FIELD CHANGE ORDER

NUMBER: DS-650Q7-F001

PROBLEM & SYMPTOM: Cross-talk problem between Dispatcher cable and switched cable. Revision incompatibility problem between M7764-00 and M7763-00 module
(See Page 3 for more details)

Solution: (Continued from Page 1)

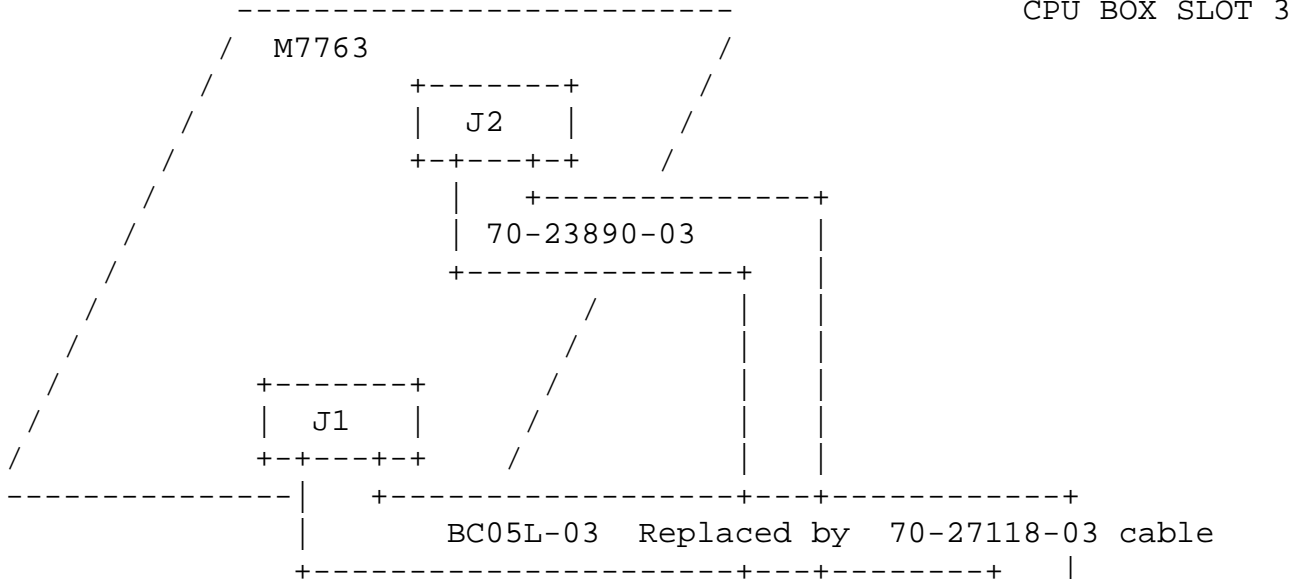
Intermittent data corruptions happen when testing switched KMV1A with MDM Diagnostics in MIRA Systems. The data was corrupted by cross-talk between cables generated by the BC05L cable between the MIRA watch-dog Module (M7763-00) and the dispatcher module (M7764-00).

A re-layout of the two modules M7763-00 and M7764-00 has been necessary to adapt the impedances between these modules. Both M7764 and M7763 become Revision E with the new etch. A new cable 70-27118 has been designed to replace the BC05L cable.

The new modules M7763 and M7764 at Rev E cannot be used with the previous Revision D or below.

Replace all modules M7763 and M7764 at Revision D or below by with new modules at Rev. E and replace BC05L dispatcher cables at one time.

DISPATCHER MODULE TO BE REPLACED

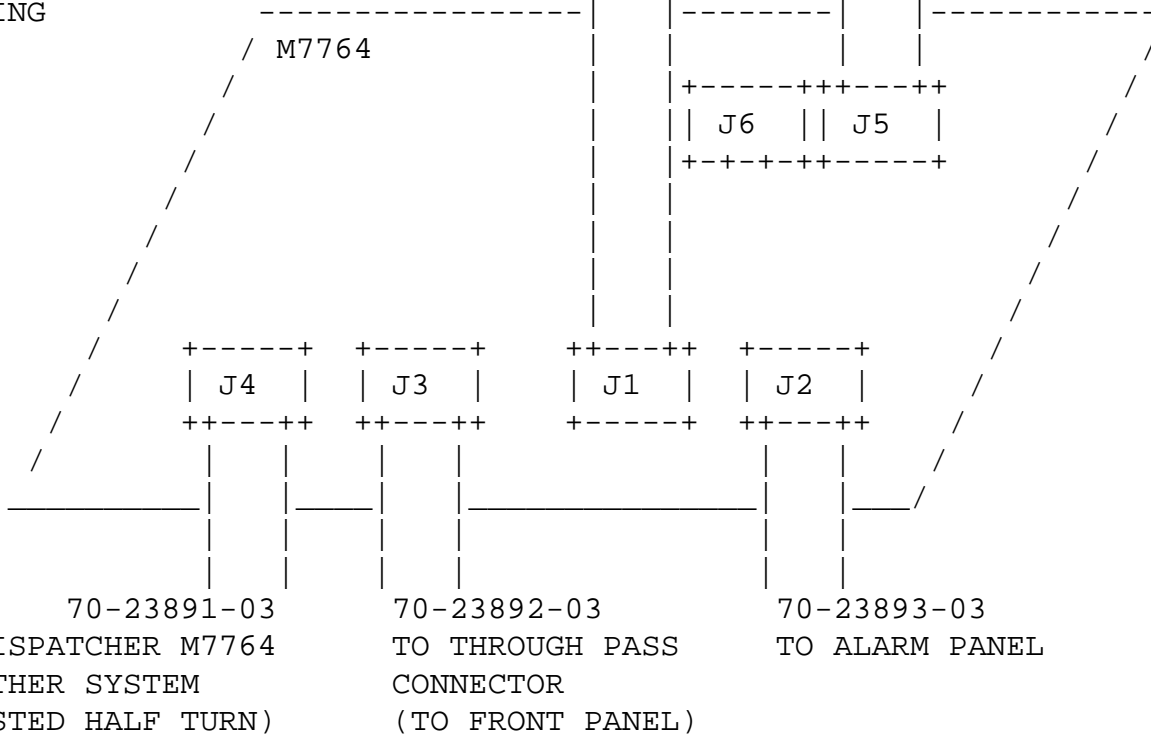
18. Route the new round cable 70-27118-03 to the switching box 0. (It will go to the dispatcher M7764 in slot 1 of this box).
19. Remove the dispatcher module M7764-00 from slot 1 of switching box 0. Note the E5 switch position on the left of the board. (See switch settings on Page 13, if necessary).

20. Disconnect cables from connectors J5, J6, J2, J1, J3, J4.
21. Reconnect cables on the new M7764-00 Rev. E module on connectors J2, J1, J3, J4. Note cables orientation especially J4 (watch-dog link).

22. Replace the BC05L-03 cable from the M7763-00 by the round cable (3 feet) 70-27118-03. Connect it to J5 (right hand side) of the M7764 module. Note that J5 and J6 locations can vary on previous revisions modules (A, B, C or D).
